UPDATED SAFETY EVALUATION REPORT

DAVIS-BESSE NUCLEAR POWER STATION, UNIT NO. 1

OPERATIONS PHASE QUALITY ASSURANCE PROGRAM

DAVIS-BESSE NUCLEAR POWER STATION
 UNIT NO. 1
 TOLEDO EDISON ORGANIZATION CHART
 FIGURE 1

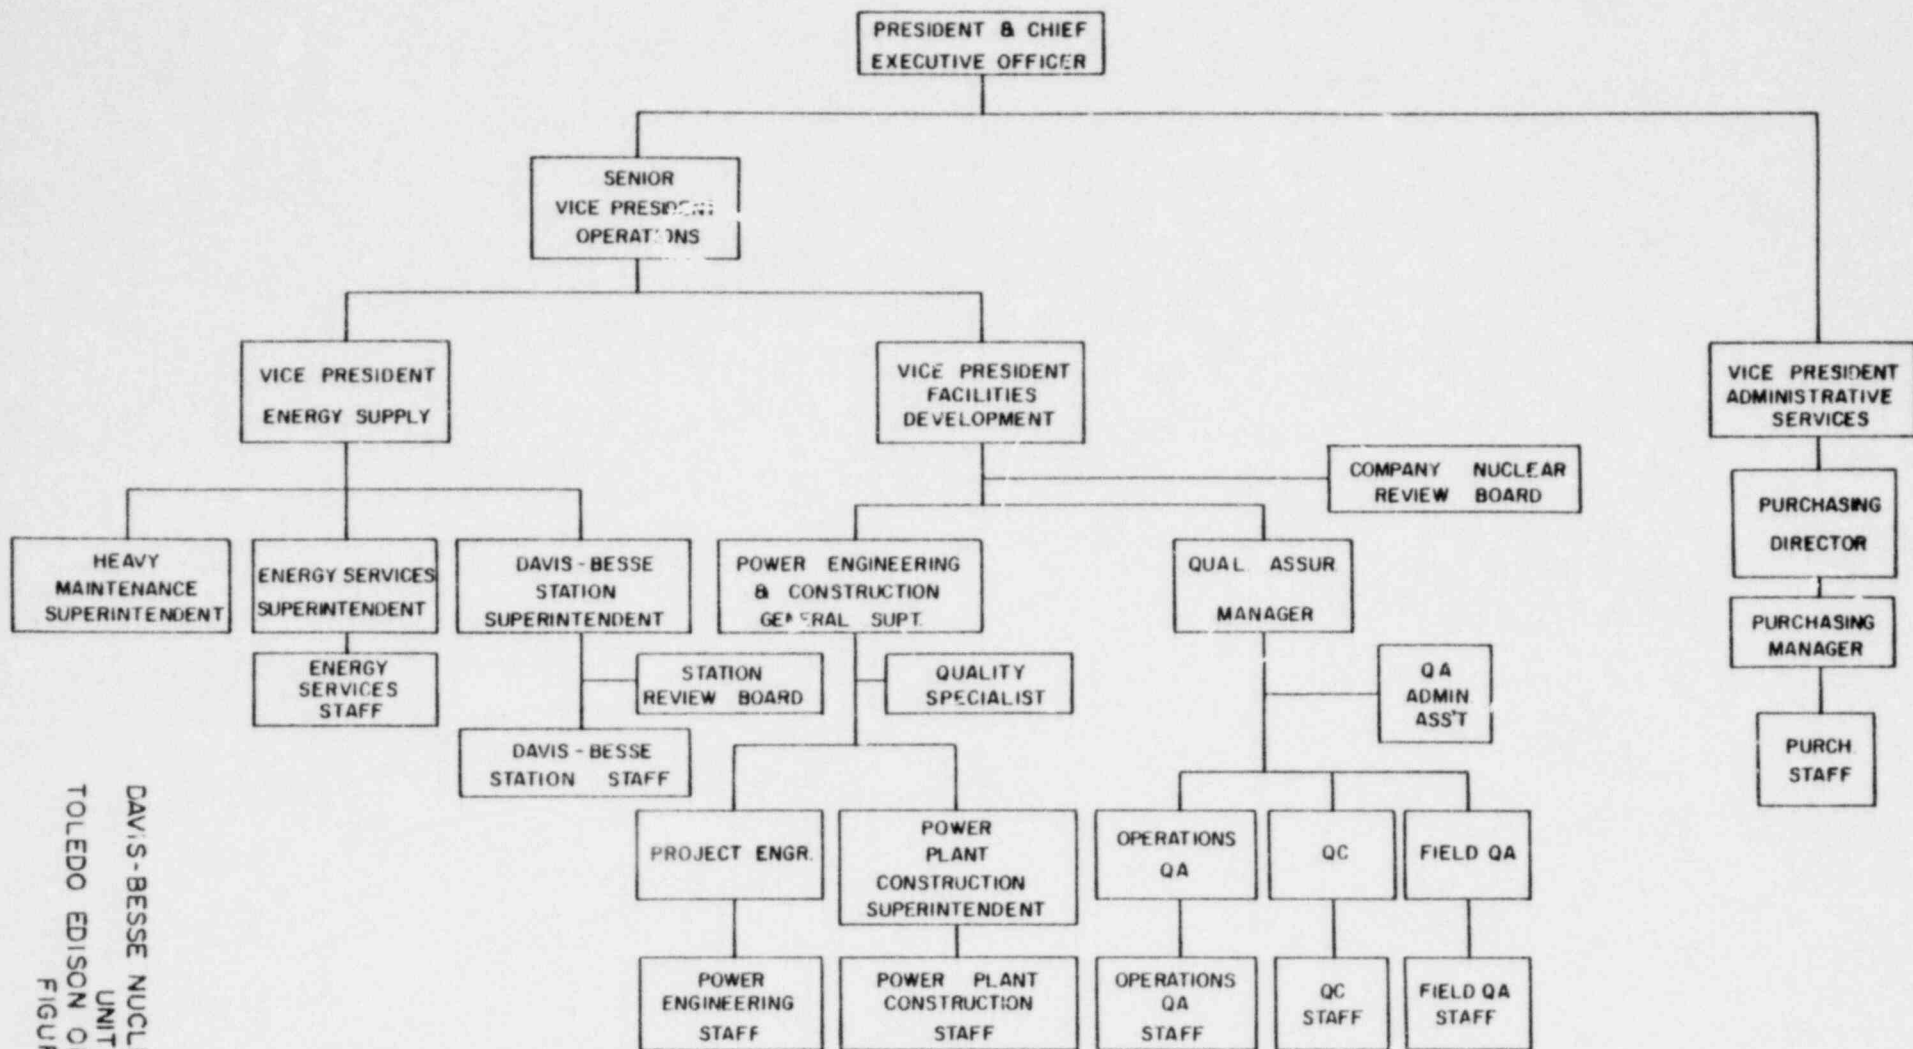
The organizational structure responsible for the operation of Davis-Besse #1 and for the establishment and execution of the operations phase QA program is shown in Figure 1. The relationships between those primarily responsible for QA and those responsible for the operation of the plant are identified in Figure 2.

The President of TE, who has the overall responsibility for the engineering, design, procurement, construction, operation, and quality assurance of Davis-Besse #1, has delegated the authority to establish and implement the QA program to the

The Station Superintendent, who reports to the Vice President - Energy Supply, is primarily responsible for operating Davis-Besse #1 in compliance with the requirements of the Operating License and the Nuclear QA Manual. The Station Superintendent and the QAM communicate directly on matters that relate specifically to the QA program. If differences of opinion on QA are not resolved jointly between the Operations QA Engineer(s) and the Station Superintendent, they are referred to the QAM. Unresolved differences culminate at the Vice President - Facilities Development for resolution.

DAVIS-BESSE NUCLEAR POWER STATION
 UNIT NO. 1
 QUALITY ASSURANCE INTERFACE
 PRINCIPLE FLOW PATHS
 FIGURE 2

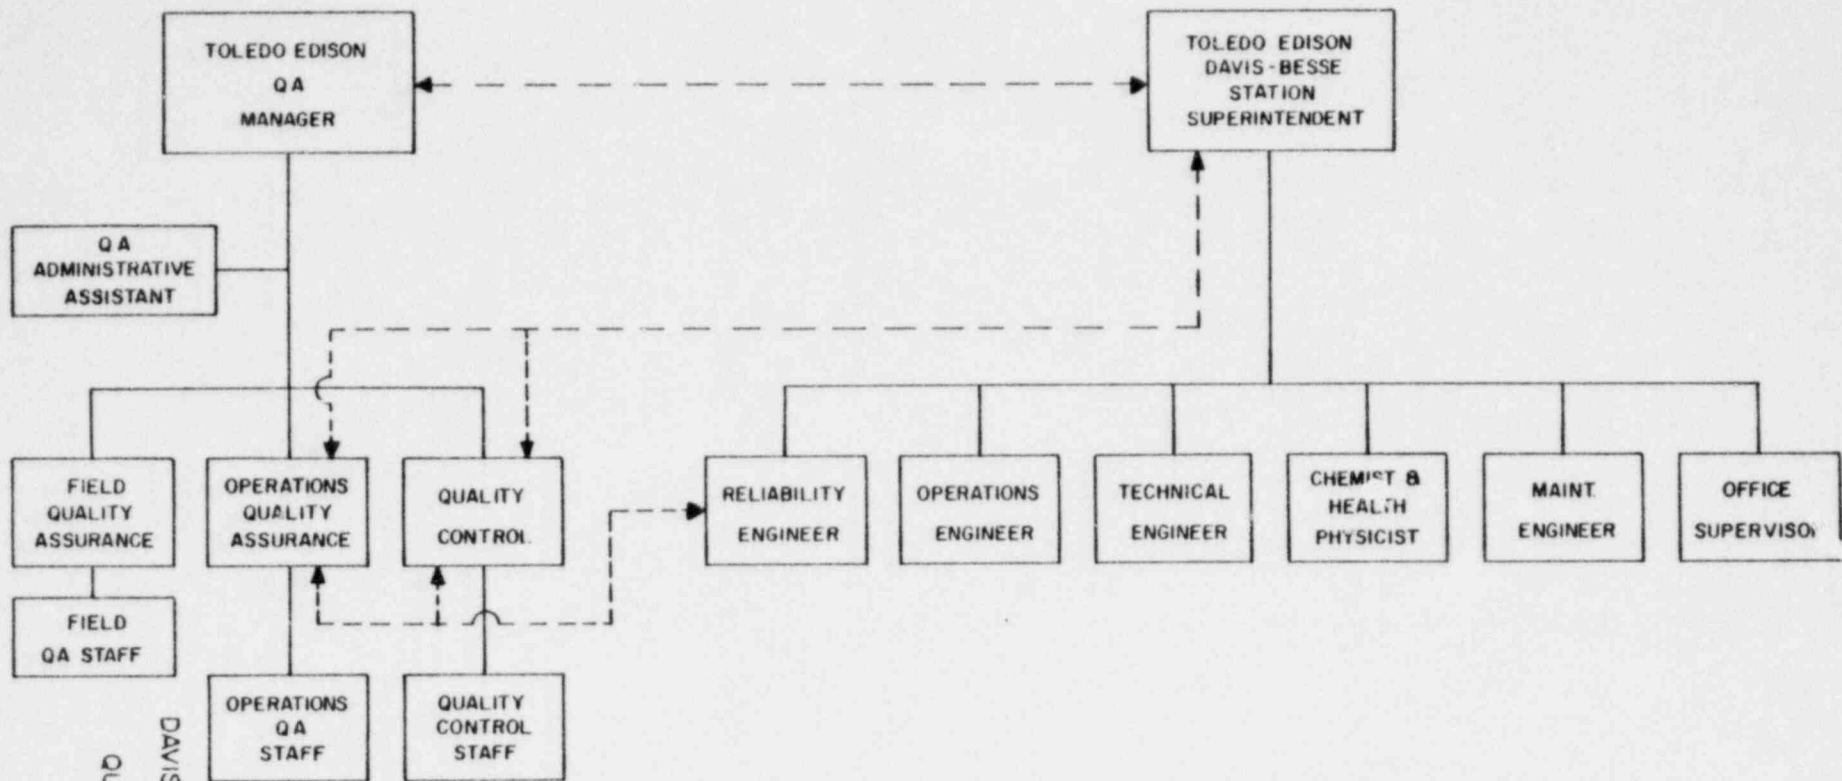
Our review of the Davis-Besse #1 QA program description for the operations phase has verified that all applicable requirements of Appendix B to 10 CFR Part 50 are included in the QA program requirements. Further, this review has determined that the QA organizations are structured such that they can effectively carry out their responsibilities related to quality without undue influence from other groups.
